Questions and Answers – 14 August 2017

Request for Quotations Number PR6561418 Gorgona Island Environmental Studies

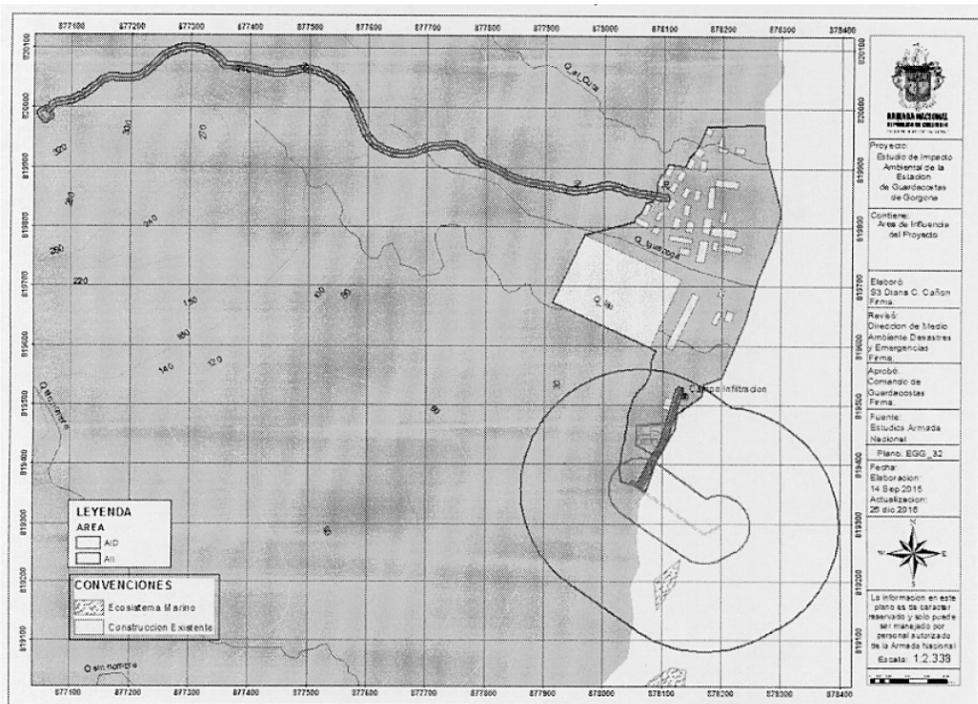
Question #21: Could you please mail us the Influence (Direct and Indirect) Project Areas Map?

Answer #21:

Corresponden a las áreas de influencia del proyecto a caracterizar:

Áreas de influencia directa:

- Área de construcción de la Subestación de Guardacostas Isla Gorgona: 2184,79 m² + 0.3 metros de entorno
- Área del radar (Cerro la Trinidad): 179.5 m² + 0.3 metros de entorno
- Muelle (área total 424,13 m²) + 100 metros (50 metros a cada lado)
- Campo infiltración Planta tratamiento aguas residuales (PTAR) (58.44 m² + 0.3 metros de entorno
- Sendero a Cerro la Trinidad: longitud desde El Poblado 960 metros + 1 metro a cada lado
- Sendero desde muelle a Estación: longitud: 60 metros + 1 metro a cada lado
- Sendero desde Estación a playa palmeras: longitud sendero + 1 metro a cada lado
- Sendero que conduce desde Estación hacia poblado: longitud + 1 metro a cada lado

Áreas de influencia indirecta:

- Área de construcción de la Subestación de Guardacostas Isla Gorgona: AID Subestación + entorno de 10 metros
- Área del radar: AID radar + entorno de 10 metros
- Área del muelle: AID muelle + 400 metros (200 metros a cada lado)
- Sendero Estación a cerro la trinidad: AID sendero + entorno 10 metros
- Sendero a playa palmeras: AID sendero + entorno 10 metros
- Franja entre el borde de la playa y el sendero que conduce a playa palmera y entre el antiguo muelle hasta el poblado con la infraestructura existente.
